Planning Commission

Agenda

April 14, 2016
City Hall, Council Chambers
749 Main Street
6:30 PM

- **Coal Creek Station Final PUD:** A request for a final plat and PUD for the existing property at the SW corner of South Boulder Road and HWY 42 owned by Coal Creek Station Properties, LLC. The project will be developed as a combination of new commercial space, to replace older existing buildings on the site and an extension of the residential neighborhood from the south.

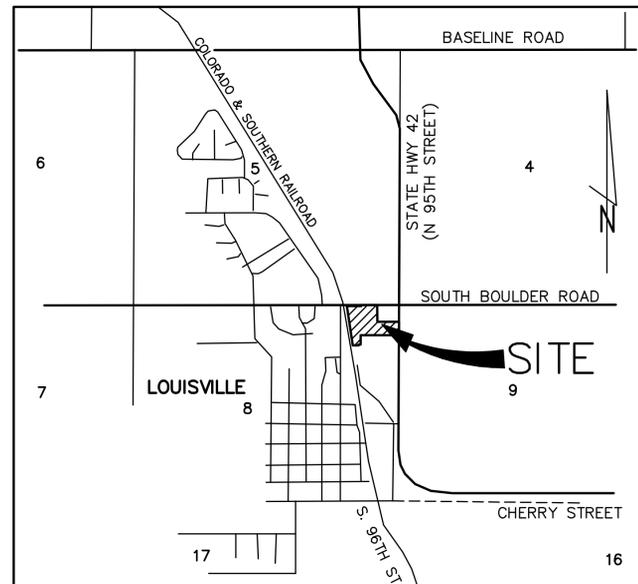
Please provide a waiver for the requirement that Building A & B meet the minimum lot coverage of 30% in the CC district, as per staff's suggestion.

Please provide a waiver for the parking for building D from 1.25 spaces per 300 SF. to 1.35 spaces per 300 SF (adds one more space) in the CC zoning district, as per staff's suggestion.

Please provide a building height waiver from 27' to 35' for the RM portion of your site which will effect 2 buildings (4 units) in the SW corner of the site, as per staff's suggestion. See * on the plan A0.0 for location.

Please provide a building height waiver from 27' to 35' for the MU-R zoning portion of your site that is within 50 feet of the RM zoning portion of your site. This effects 1 building (2 units) in the SW corner of the site, as per staff's suggestion. See * on the plan A0.0 for location.
